**KIRTLAND AIR FORCE BASE
COMPREHENSIVE GROUNDWATER MONITORING EVALUATION**

**DR. BRUCE A. SWANTON
Hazardous and Radioactive Materials Bureau
New Mexico Environment Department**

May 6, 1991

COMPREHENSIVE GROUNDWATER MONITORING EVALUATION REPORT (CME)

Figure 3-1
Borehole Location Map - Sewage Lagoons

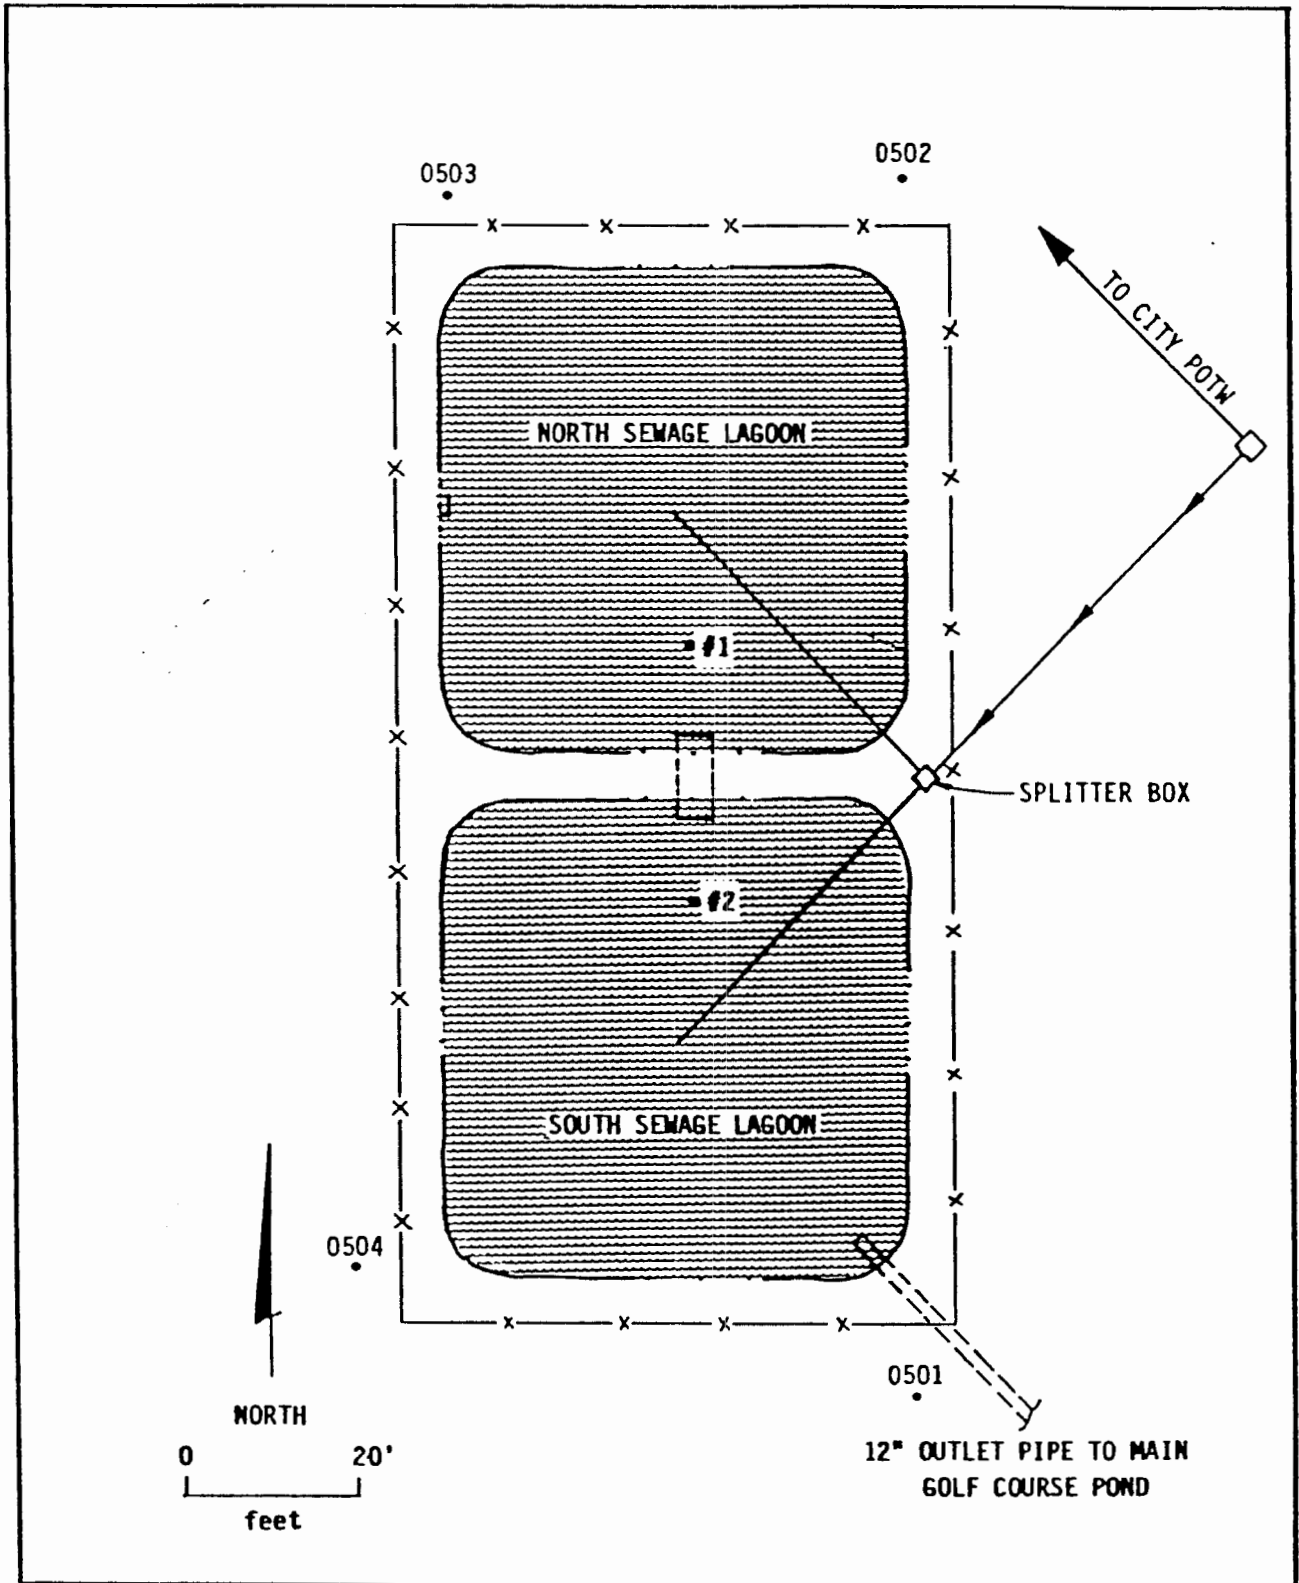
Y soil borings? **SEE UNIT CLOSURE PLANS FOR SEWAGE LAGOONS (FIGURE 3-1) AND GOLF COURSE POND, (FIGURE 5-1). NOTE THAT FOR GOLF COURSE POND, BOREHOLES 0610, 0602, 0609 AND 0608 WERE FINISHED AS MONITORING WELLS, AND THAT BOREHOLES 0601, 0603 AND 0604 WERE FINISHED AS LOGGED 100 FOOT BOREHOLES. FOR SEWAGE LAGOONS, ALL BOREHOLES WERE LOGGED TO 100 FEET AND FINISHED AS MONITORING WELLS (0503, 0502, 0504, AND 0501).**
